CONSERVATION MANAGEMENT PLAN

LOCOMOTIVE “BLACKIE”

COMMENTS ON PRASA DISPLAY PROPOSAL

CAPE TOWN STATION

**COMMENTS ON SITE LAYOUT OF DISPLAY POSITION
IN FORECOURT OF CAPE TOWN STATION
AS PROPOSED BY PRASA**

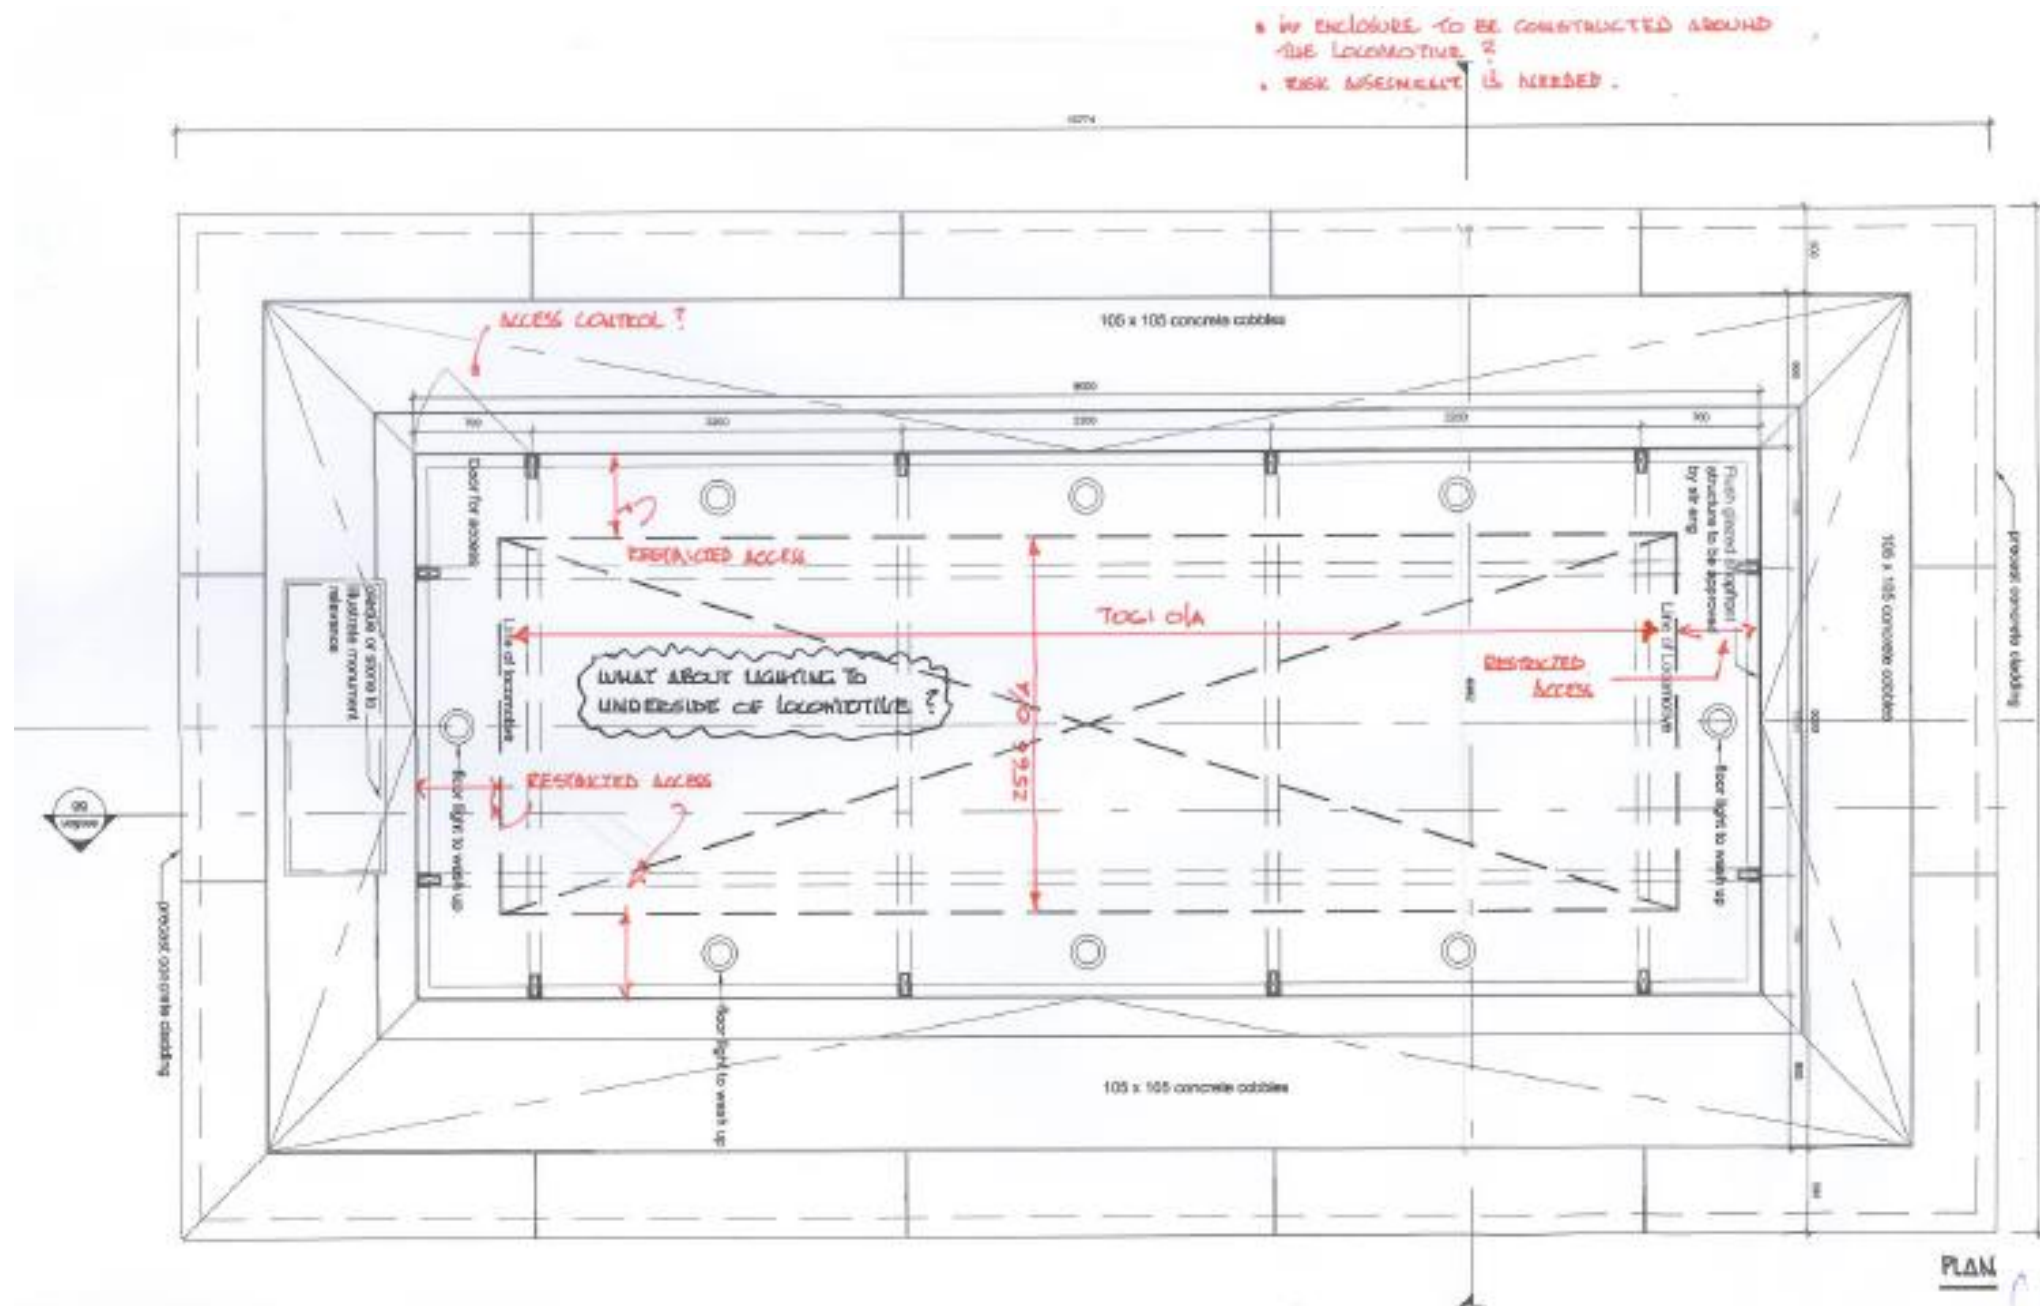
1.2.10. Having inspected the proposed location in-situ with PRASA and SAHRA on 04 February 2015 as well as inspecting the Station Concourse we believe that there are alternate locations within the Station Concourse that should be considered as well as options utilising the PRASA proposed site but with a proper building to house and shelter "Blackie"
